Access Compliance Report

Public Rights-of-Way

Intersection ID: 47628	Main Street: EASTFIELD_RD	Cross Street: WALLACE_POND_DR	Location: NW
ADA ID: 4F0575758C50	Ramp Type: BlendTrans1	Initial Pass/Fail: Fail	Overall Compliance: No
		Severity Score: 21.25

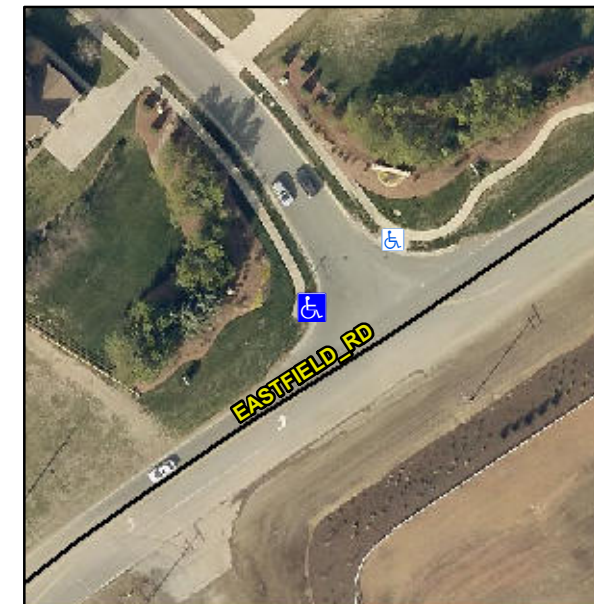
Remove & Replace Curb Ramp With Two New Directional Ramps or Equivalent.

R304.5.1, R304.5.3

Compliance	Description	Data	Compliance	Description	Data
N/A	Ramp Length (in)	71.0	Yes	BlendTrans Slope (%)	1.4
No	Ramp Width (in)	47.0	No	BlendTrans XSlope (%)	5.1
N/A	Flare Type LT	N/A	N/A	Flare Type RT	N/A
N/A	Flare Slope LT (%)	N/A	N/A	Flare Slope RT (%)	N/A
N/A	Flare Traversable LT?	N/A	N/A	Flare Traversable RT?	N/A
N/A	Landing Length (in)	N/A	N/A	DWS Provided?	N/A
N/A	Landing Width (in)	N/A	N/A	DWS Contrast?	N/A
N/A	Landing Slope (%)	N/A	N/A	DWS Length (in)	N/A
N/A	Landing X Slope (%)	N/A	N/A	DWS Full Width?	N/A
N/A	Landing Curb? (Y/N)	N/A	N/A	DWS Offset (in)	N/A
N/A	Shared Landing?	N/A			
N/A	Gutter Ponding?	N/A	N/A	Gutter Slope (%)	N/A
N/A	Gutter Lip Ht (in)	N/A	N/A	Gutter X Slope (%)	N/A
N/A	Painted X Walk1?	No	N/A	Painted X Walk2?	N/A
	X Walk 1 Direction	To NE		X Walk 2 Direction	N/A
	X Walk 1 Width (in)	N/A		X Walk 2 Width (in)	N/A
	X Walk 1 Slope (%)	2.4		X Walk 2 Slope (%)	N/A
	X Walk 1 X Slope (%)	5.0		X Walk 2 X Slope (%)	N/A
